HADDAM NECK PLANT

Docket No. 50-213  
CY-02-075  
Re: 10CFR50.90

Haddam Neck Plant  
Proposed Technical Specification Change  
Response to Request for Additional Information

*Figure 1*

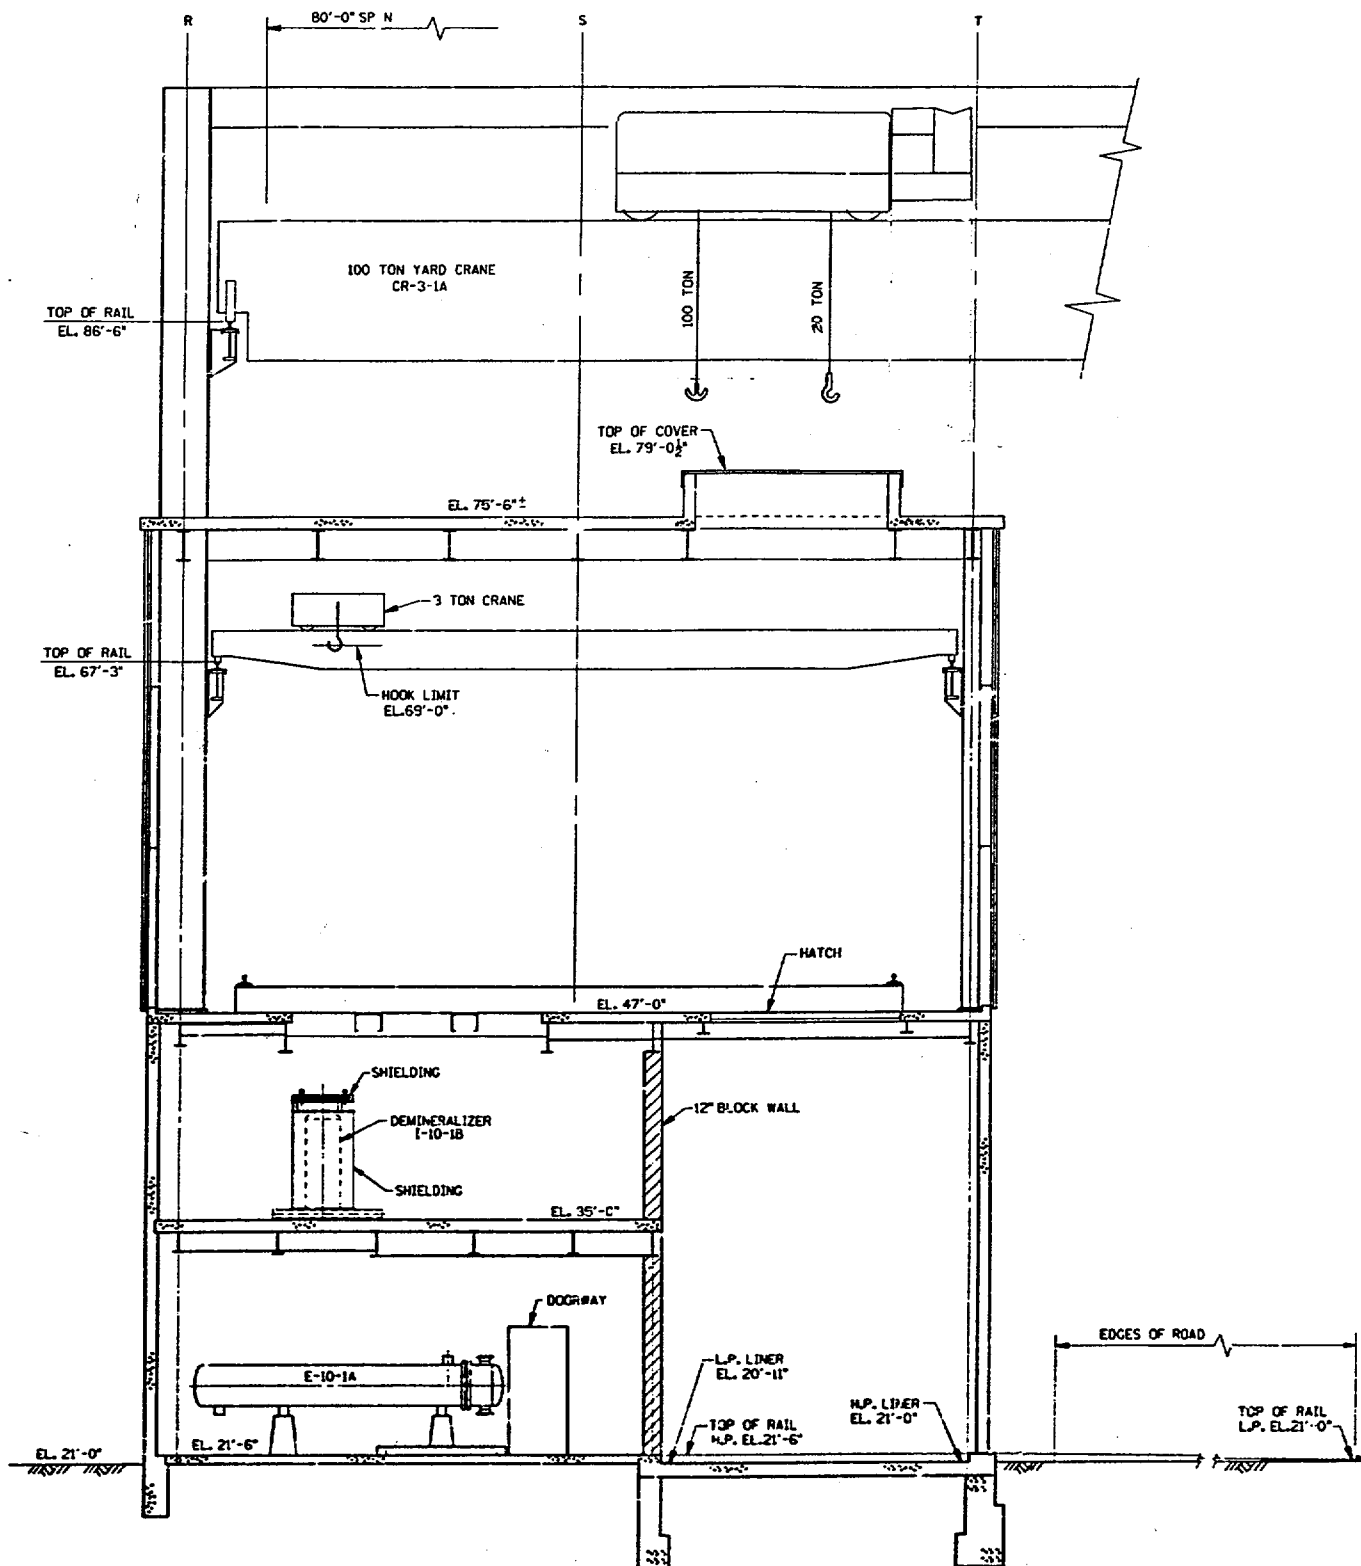
- a. Describe the geometry of the crane supporting structure and the type of connections between the crane and the supporting structure, and any structural modifications of the supporting structure resulting from the crane upgrade.

*The Connecticut Yankee 100-ton Yard Crane supporting structure is a steel frame consisting of rigid frame construction in the east/west direction and braced frame construction in the north/south direction. Connections are primarily shop welded and field bolted. The supporting structure is founded mostly on concrete piers at grade, but has two main columns, which are founded on the elevated upper edge of the Spent Fuel Pool. In addition, the structure provides some common framing for the Spent Fuel Building. To provide additional lateral support in the east/west direction, the structure is braced off at its midpoint to the side of the containment at its uppermost elevation. Figures depicting a cross section of the SFB and defining the crane supporting structure are attached.*

*Aside from routine maintenance, no significant changes to the supporting structure have been made since its original installation. The supporting structure will not require modification as a result of the analysis performed to qualify the crane as a single-failure-proof crane.*

# SUMMARY OF SUPPORT CONDITIONS FOR YARD CRANE

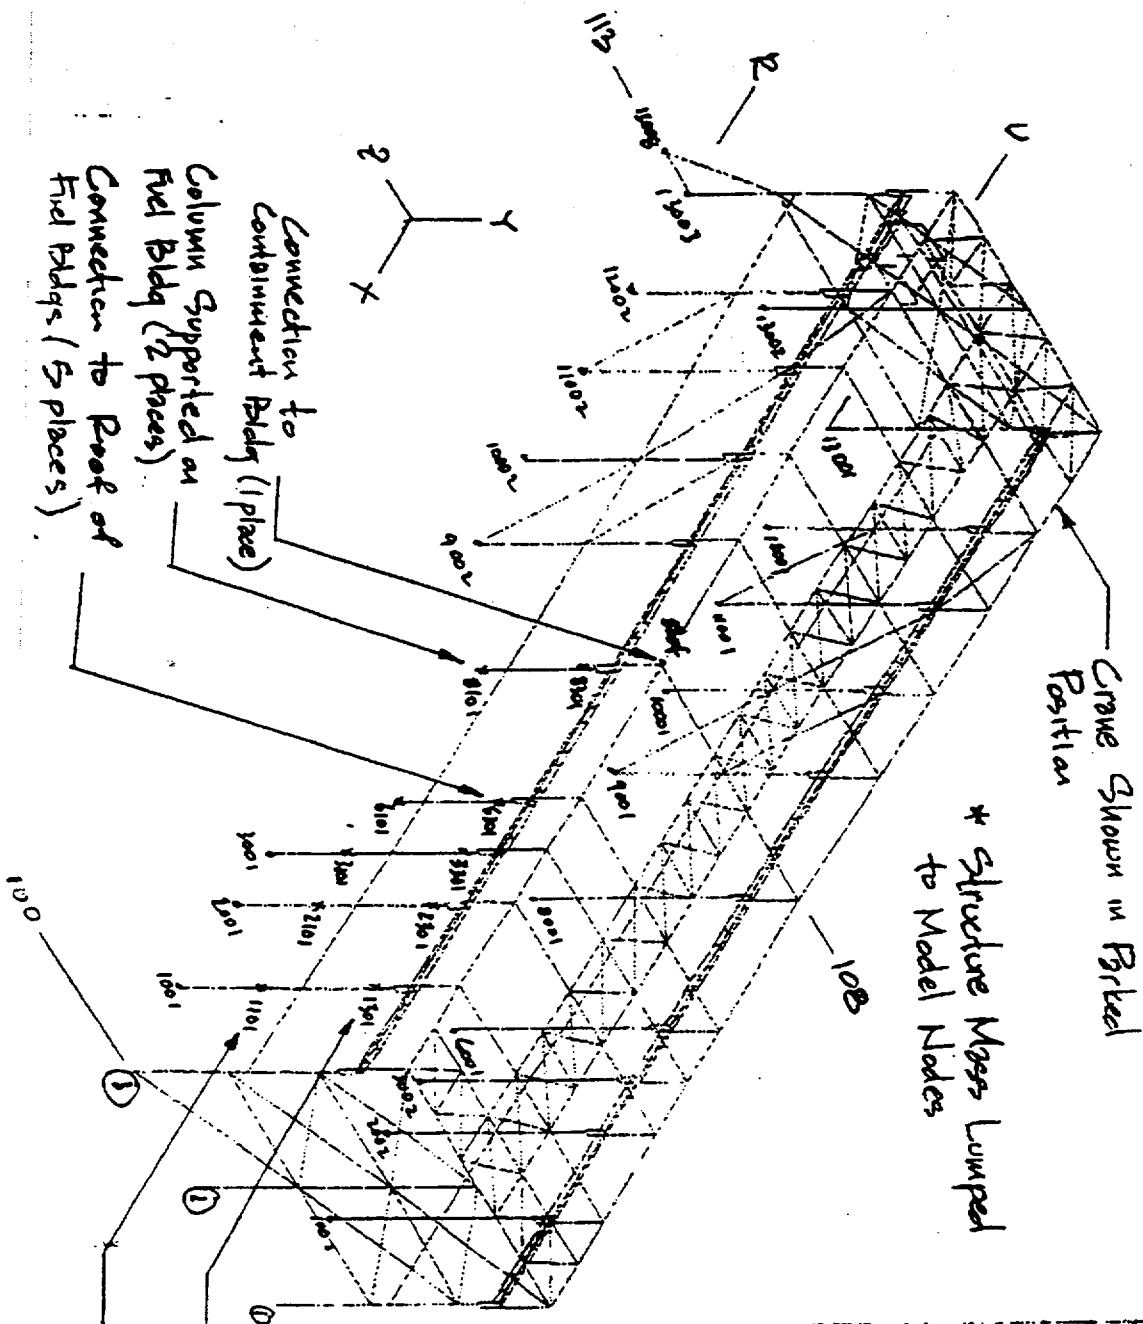
4. Provide details concerning how the crane bridge and trolley were modified and the effects of these modifications on the structural integrity of the crane and its ability to operate as an integrated system.

*The method of analysis was to construct a relatively simple model (Figure 4) to closely approximate the behavior of the existing runway structure and give an accurate prediction of the forces in the bridge crane, trolley and rope. The runway structure with its permanent components, the Yard Crane bridge and the trolley were modeled with a 3-D frame model. The GT-STRUDL (Version 9901 NT) computer program was used to produce a linear elastic finite element model of structure's geometry, loadings and dynamic response.*

*During the analysis the existing trolley rail-girder configuration did not meet the limiting bearing stress in the diaphragm under the rated load case. The modification to the bridge to correct this was to install a reinforcement plate underneath the trolley rails for the entire length of the bridge girders. The existing welded trolley rails were removed from the girder top plates. Reinforcement plates were installed on top to the girders along with new rails on top of the plates. The replacement connections for the rails were made with rail clips.*

*Based upon the above modification, it was concluded that the bridge crane system was adequate for the rated load for the CMAA load cases and the SSE seismic event. The analysis indicated no wheel uplift for the bridge or trolley wheels during a SSE seismic event.*
